REQUEST FOR DRB APPROVAL FOR:  
DANDEKAR RESIDENCE

DRB21-0643

## **Modified Conditions**

FILE NO: DRB21-0643

WAIVER(S)  
2. REQUEST TO WAIVE THE MAXIMUM BUILDING HEIGHT  
FROM 24'-0" TO 26'-0".

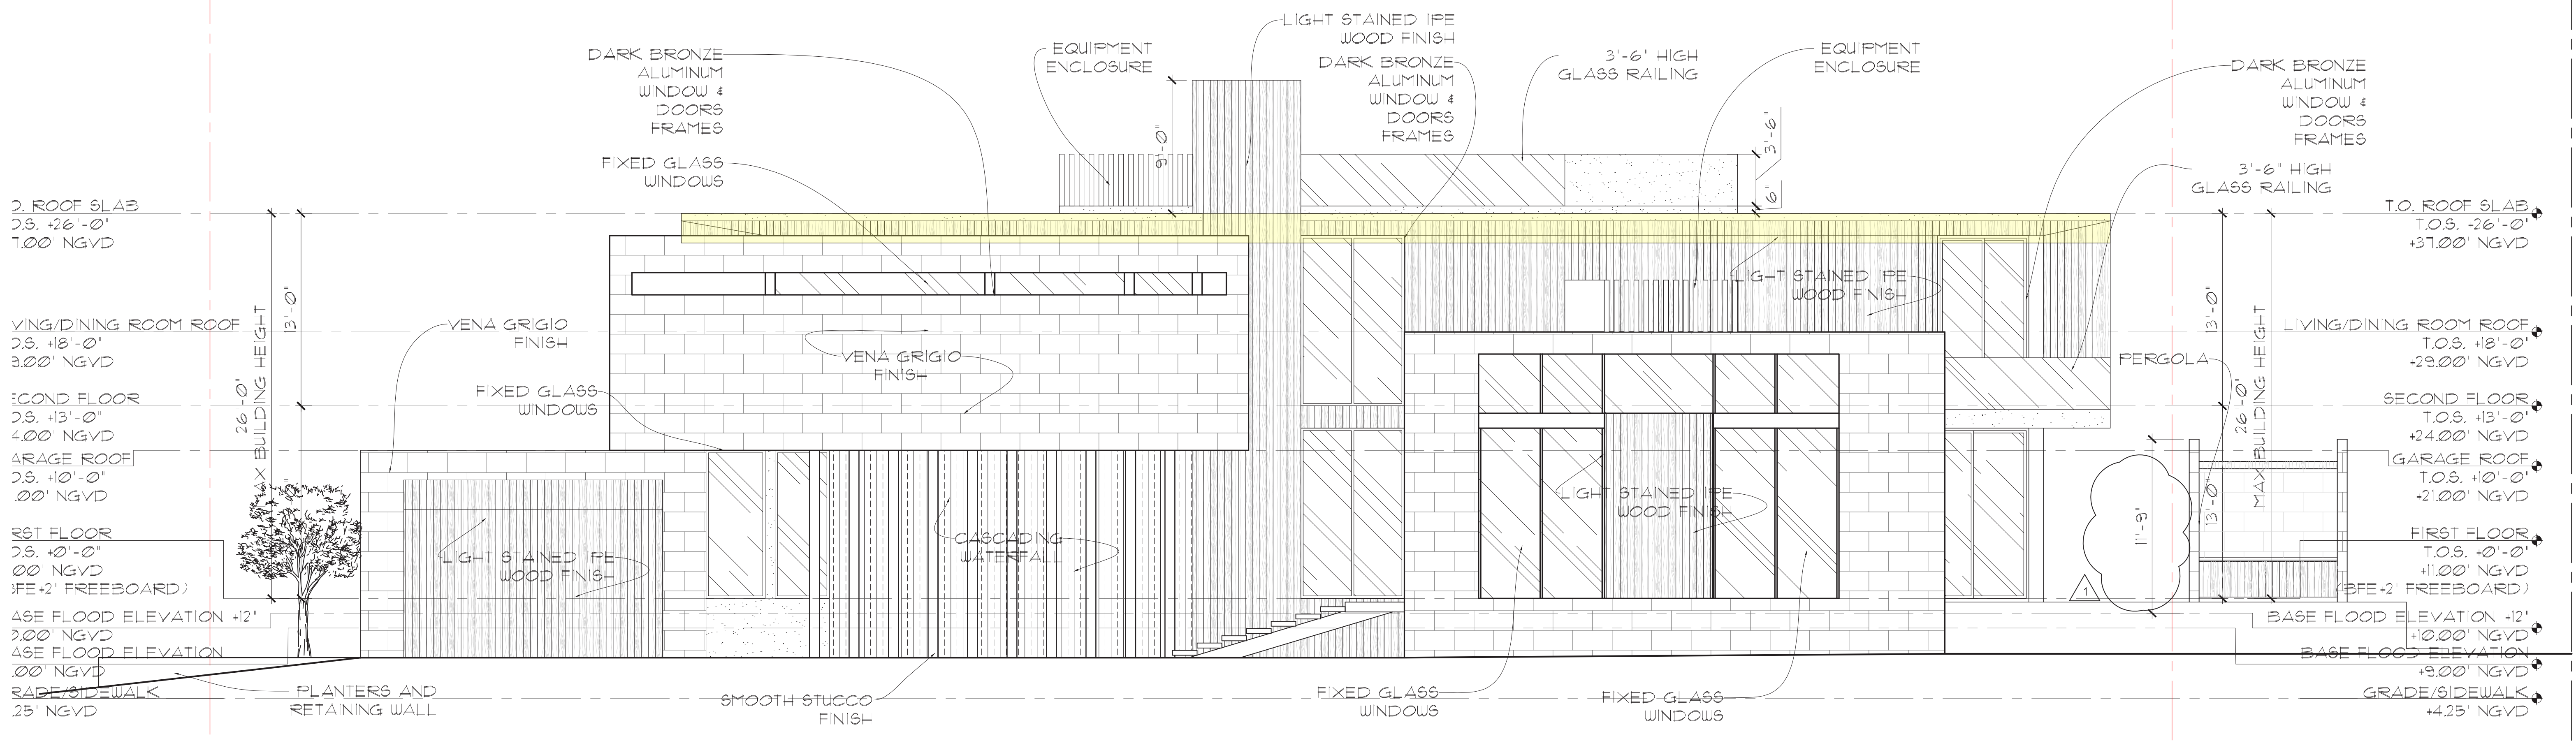
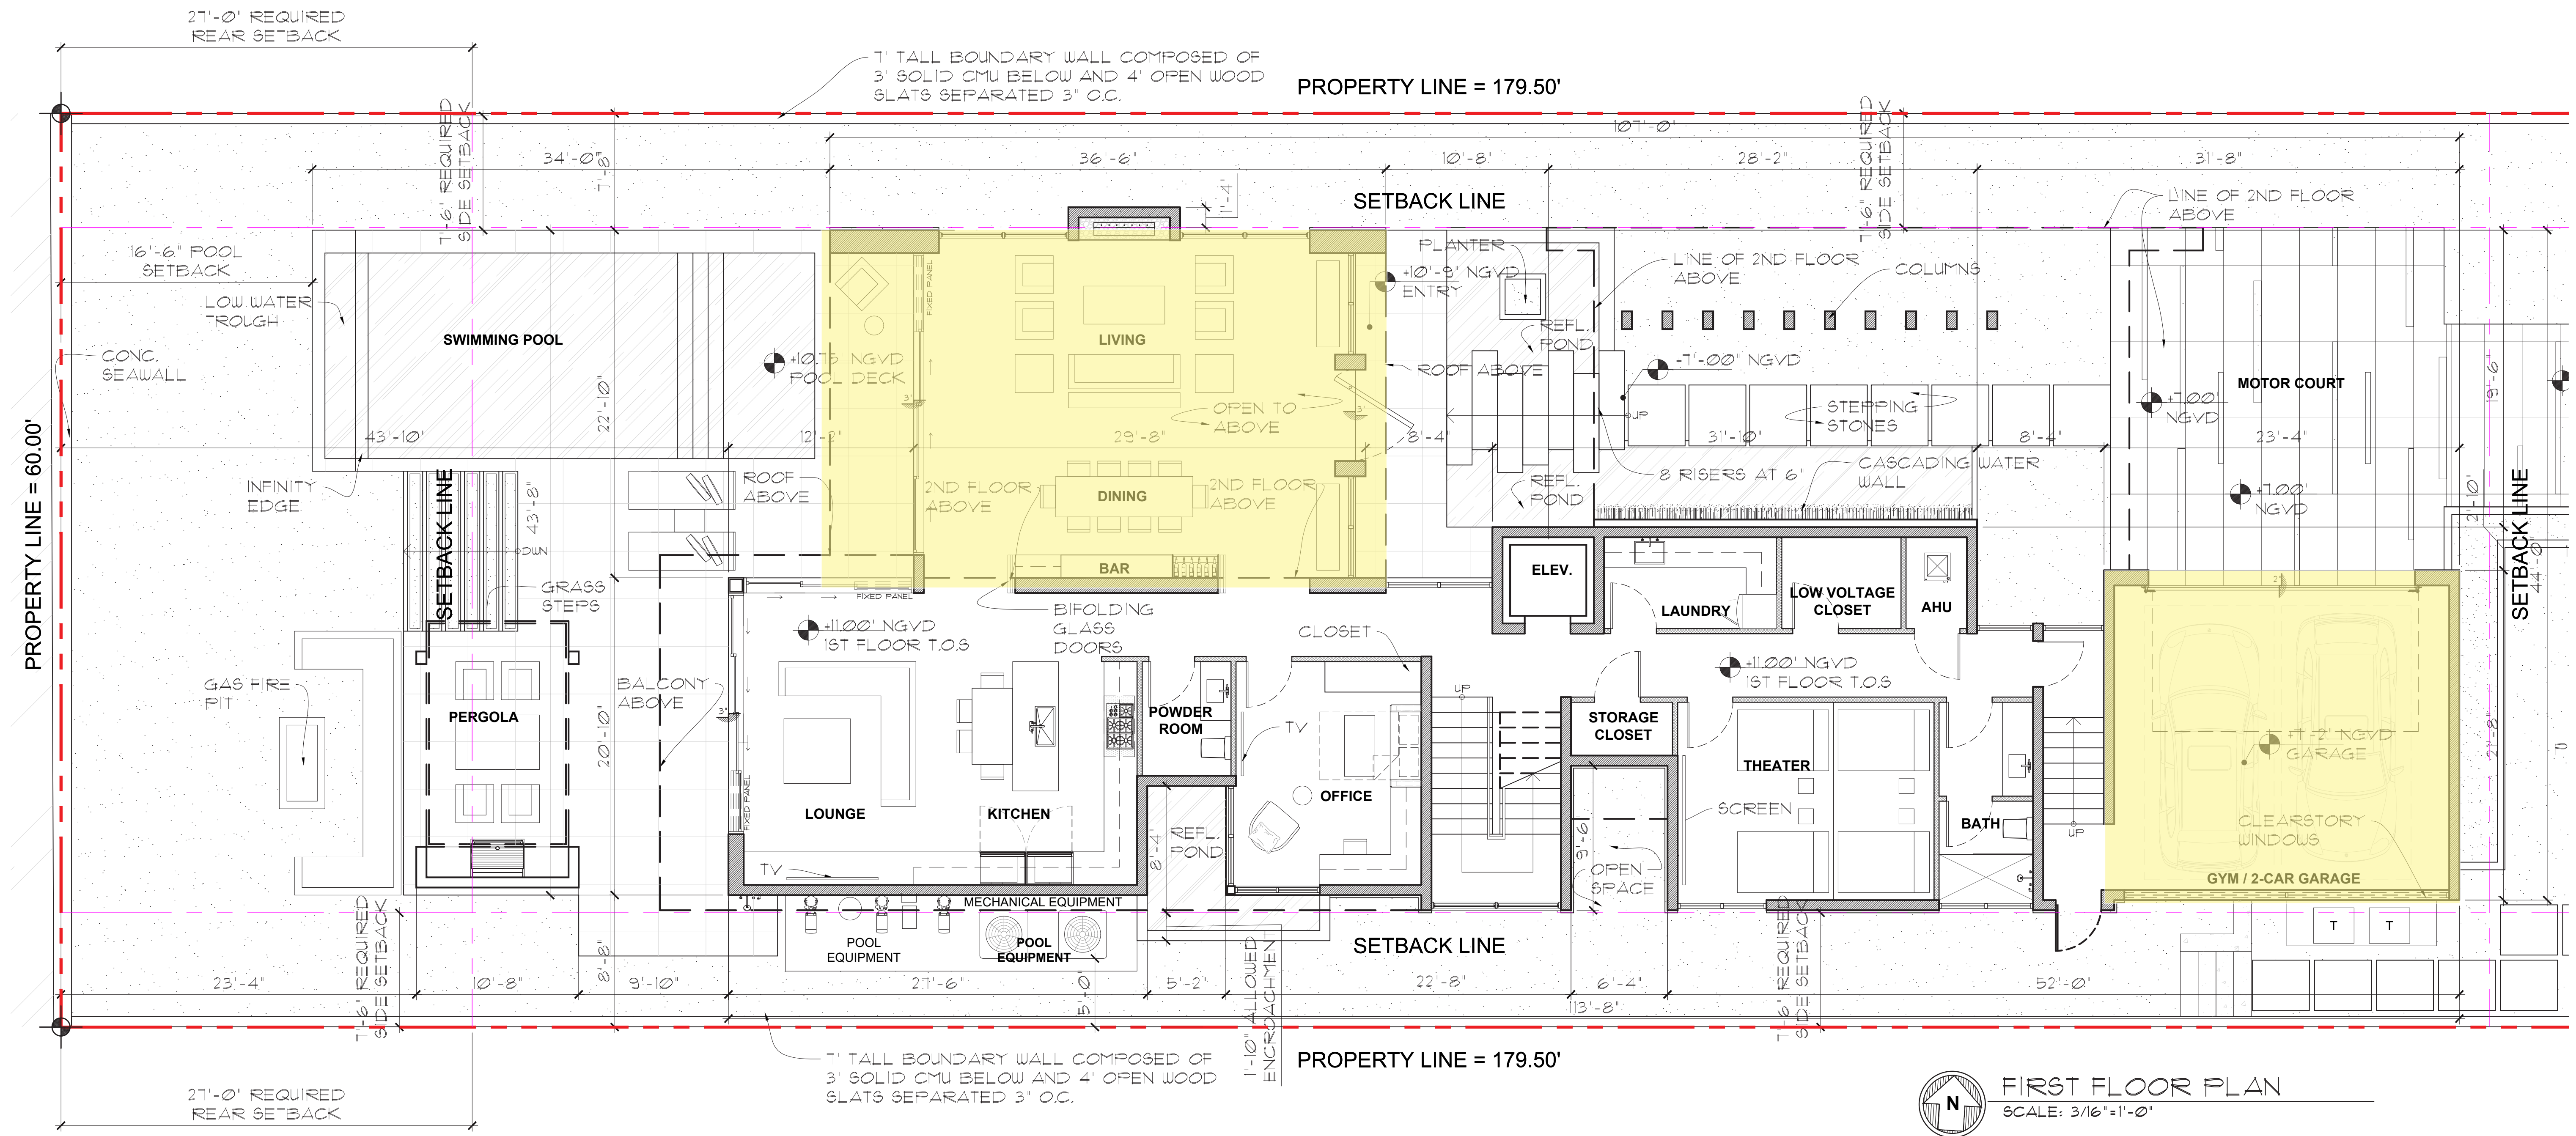
a. The proposed 2'-0" increase in height ~~shall not~~ be permitted as proposed; the maximum height of the two-story structure shall be ~~24'-0"~~ 26'-0" when measured from BFE + 2'-0" freeboard.

**FIRST FLOOR PLAN**  
SCALE: 3/16"=1'-0"

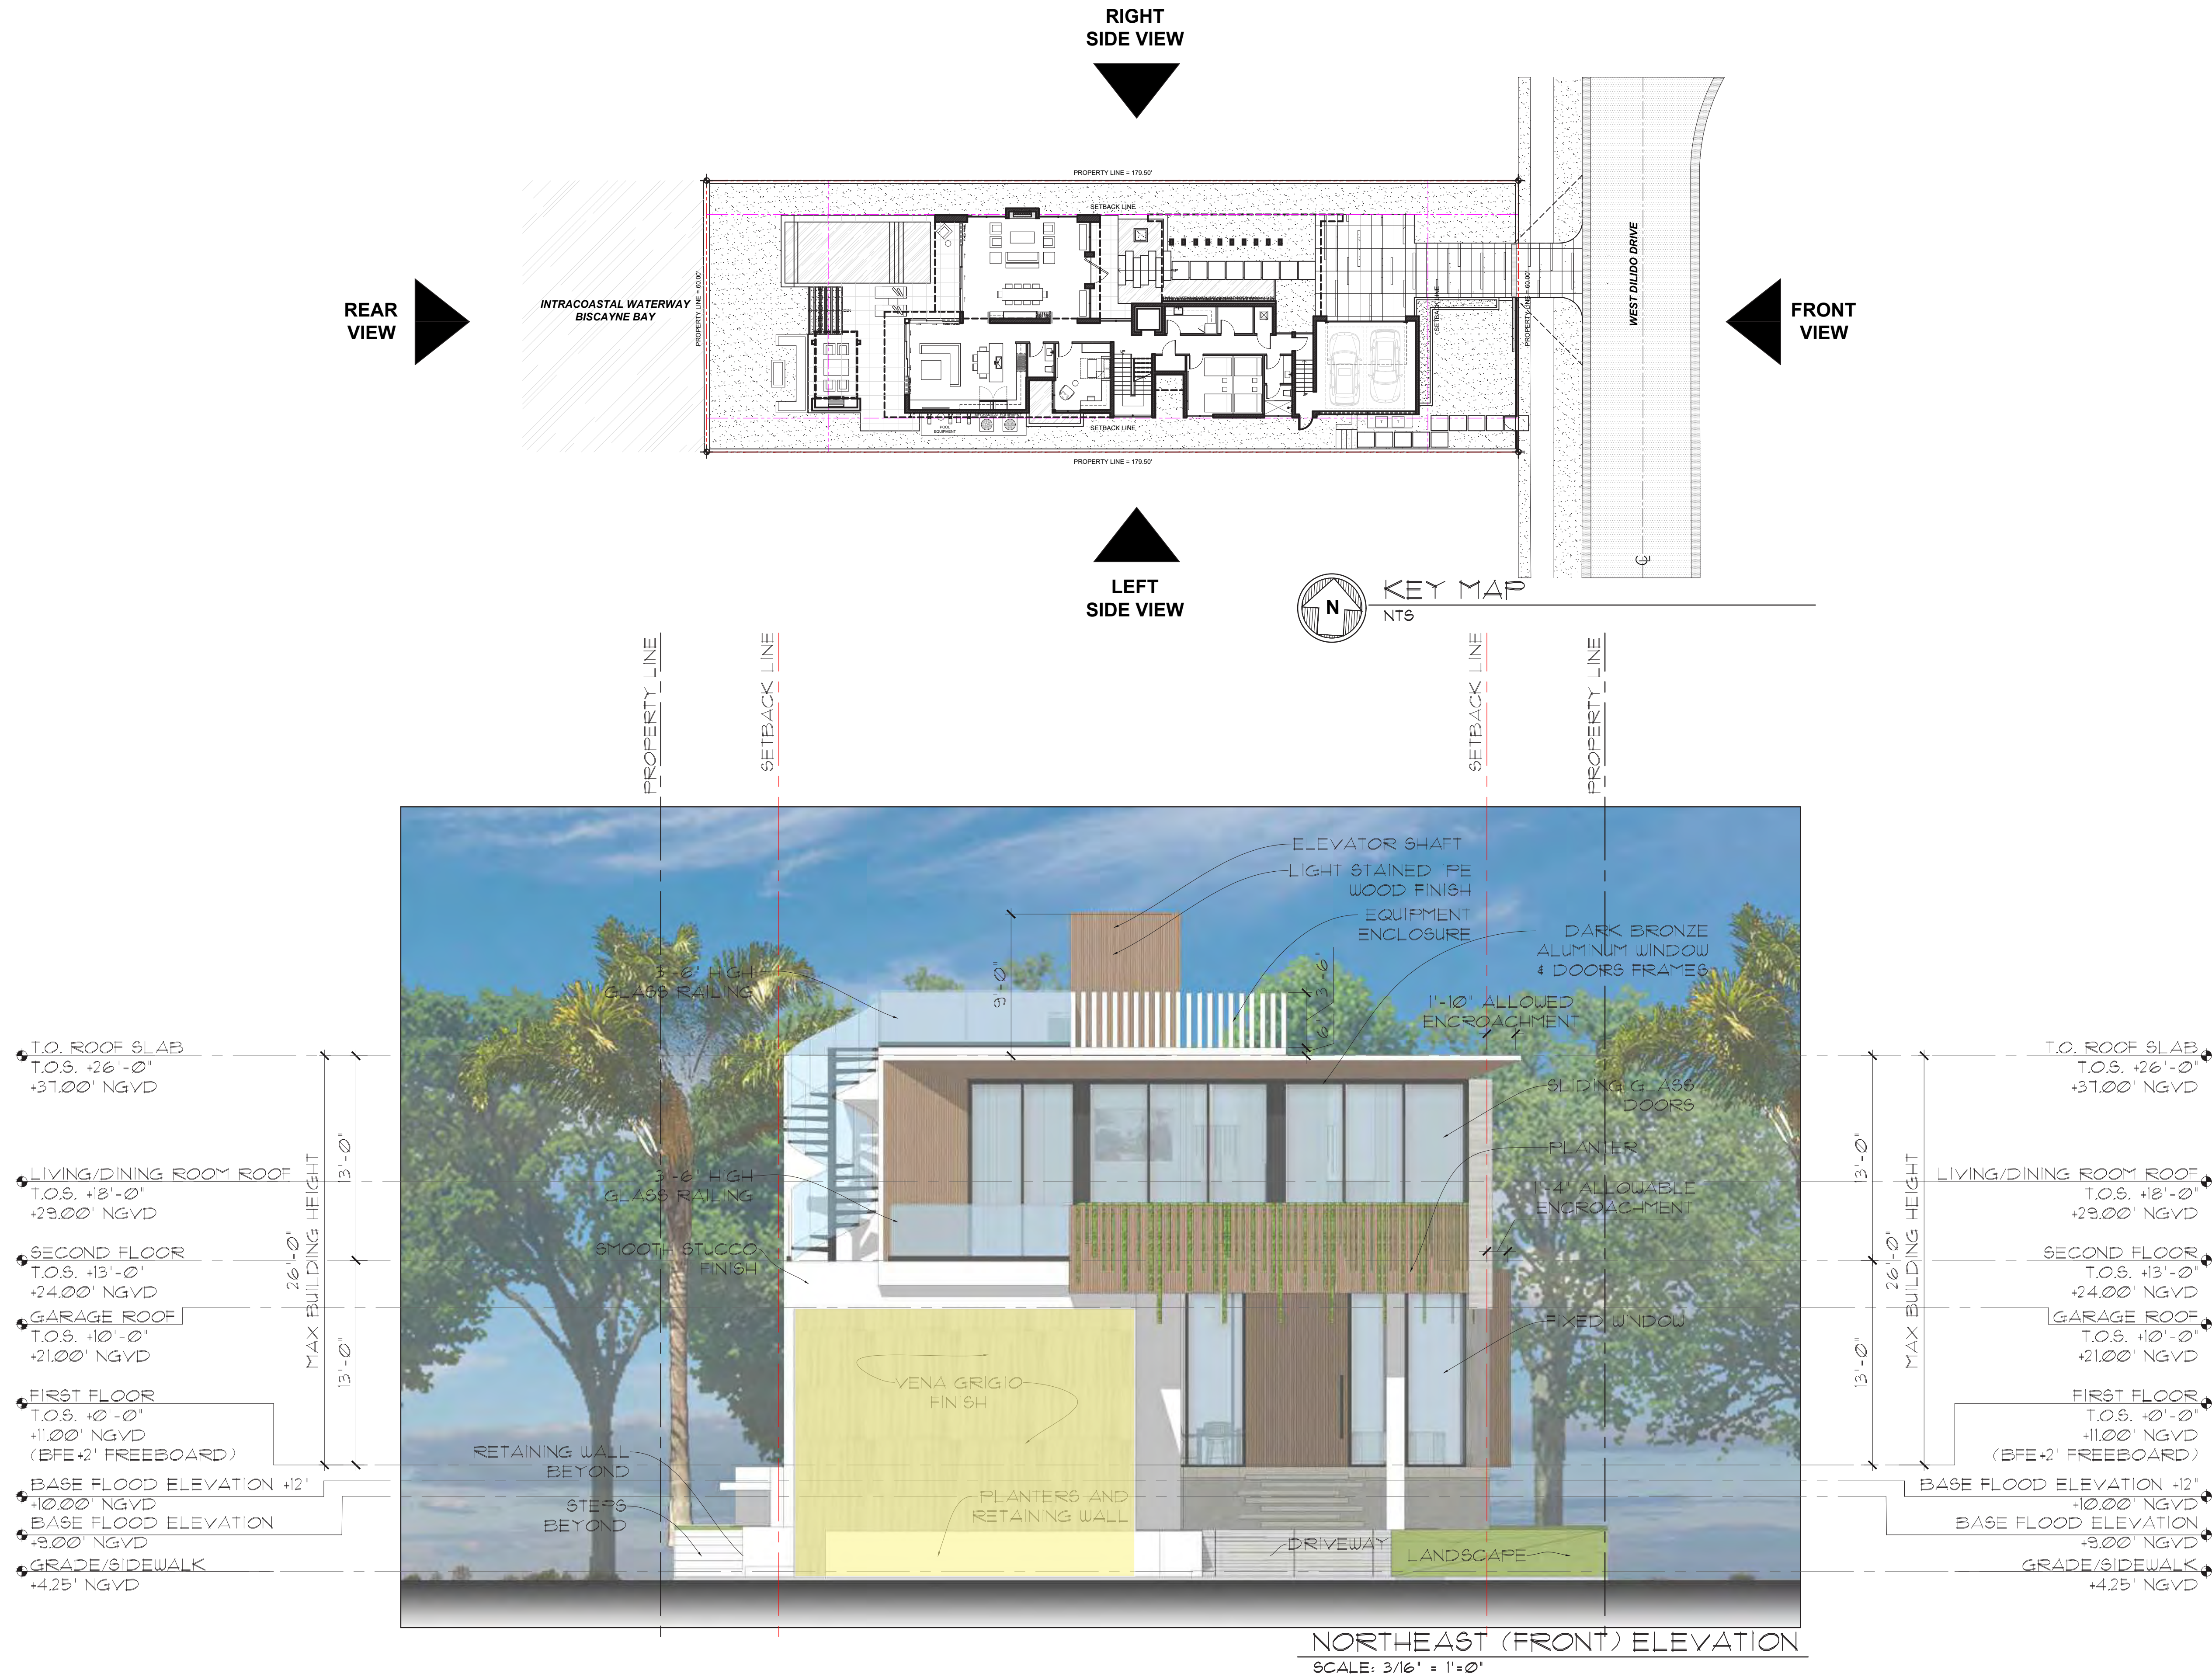
f. The protruding niche proposed along the first floor of the ~~south~~ north elevation, at the living room, is ~~not~~ an allowable encroachment into required yard, up to 25% not to exceed 6', whichever is less, and shall ~~not~~ be approved as proposed.
